SUBDIVISION REVIEW SHEET

CASE NO.: C8-2016-0042.0A**P.C. DATE:** February 28, 2017**SUBDIVISION NAME:** Resubdivision of Lot 3C: Amended Plat of Lots 3A, 3B & 3C,
Bunche Road Subdivision**AREA:** 0.906 acres**LOT(S):** 3**OWNER/APPLICANT:** Bodhi Group, LLC
(Yusof Johnson)**AGENT:** Land Answers, Inc.
(Jim Wittliff)**ADDRESS OF SUBDIVISION:** 1809 Webberville Rd.**GRIDS:** M23**COUNTY:** Travis**WATERSHED:** Fort Branch**JURISDICTION:** Full**EXISTING ZONING:** MF-3-NP**NEIGHBORHOOD PLAN:** M.L.K. – 183 / East M.L.K. Combined**PROPOSED LAND USE:** Single-Family

MEMORANDUM

SUBJECT: C8-2016-0042.0A Resubdivision of Lot 3C: Amended Plat of Lots 3A, 3B & 3C, Bunche Road Subdivision

RESUBDIVISION OF LOT 3C: AMENDED PLAT OF: LOTS 3A, 3B & 3C, BUNCHE ROAD SUBDIVISION

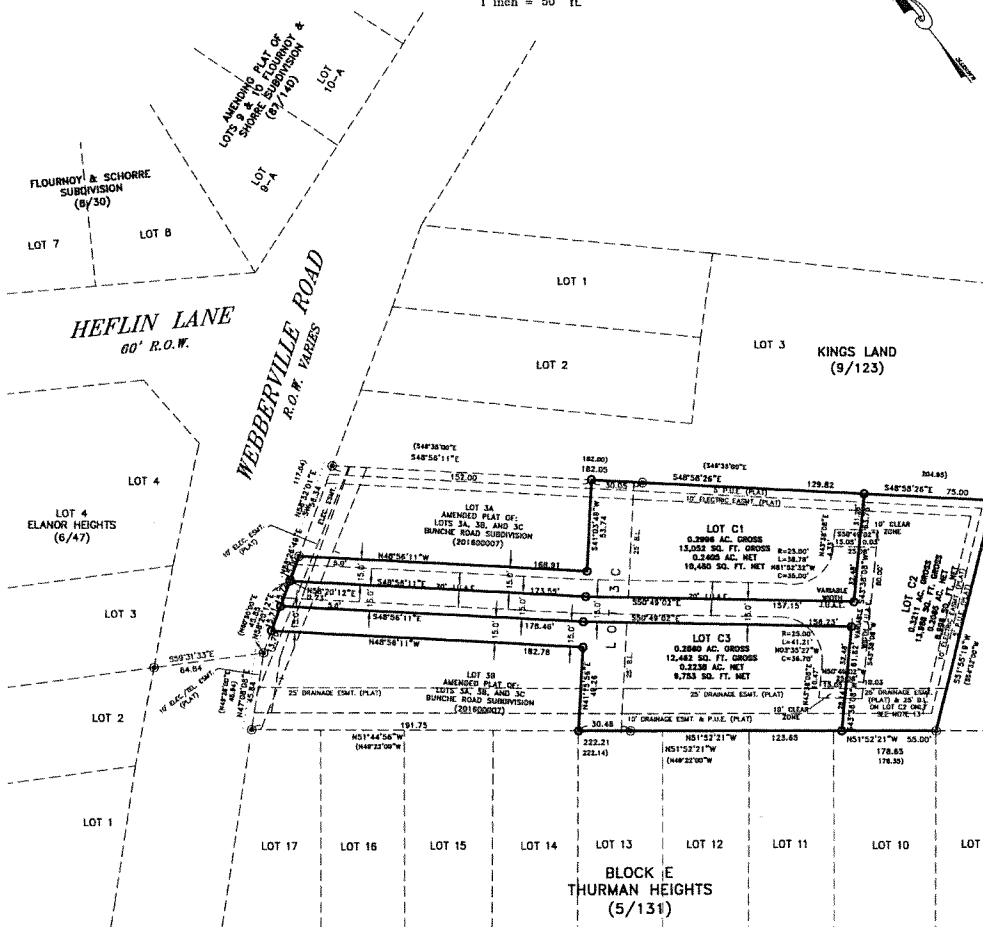
VARIANCES: A variance to section 25-4-175 to allow a residential flag lot(s) has been requested. The applicant is proposing three residential flag lots with this application. The applicant has obtained approval from the Fire Department to verify accessibility for emergency responders, approval from the Austin Water Utility, Austin Energy, and the City Arborist to verify there is adequate room for the required utilities and enhanced tree protection on the site. It is the Staff's opinion that the proposed subdivision is compatible with the surrounding development, and is consistent with other flag lots within the neighborhood. It should also be noted that there are no known deed restrictions on the site, and a note has been added that requires all addresses for residential lots utilizing a flag lot design must be displayed at their closest point of access to a public street for emergency responders. Because the application meets the flag lot criteria as required by the Land Development Code, the Staff recommends approval of the variance.

The applicant for the above referenced subdivision application has requested a variance from Section 25-4-175(A)(2) of the Land Development Code to utilize a flag lot design for a resubdivision creating three residential lots. In reviewing the variance request, staff evaluated the request based upon the criteria below, (see criteria and staff response):

The applicant has met with Austin Fire Department review staff and AFD staff has determined that the flag lot configuration proposed will not inhibit accessibility for emergency responders.

The applicant has provided a driveway and utility plan to reviewers for the City of Austin Water and Wastewater review and Austin Energy Departments. The reviewers have determined after review of the utility/driveway plan that there is adequate room to provide utility service to both lots and utilities will not cross the proposed new lot lines.

The applicant has provided a tree survey to arborist staff with the City of Austin and the arborist have no objections or further recommendations.

Based upon review of these criteria, staff **recommends** the variance request to develop a flag lot as a part of this resubdivision request.
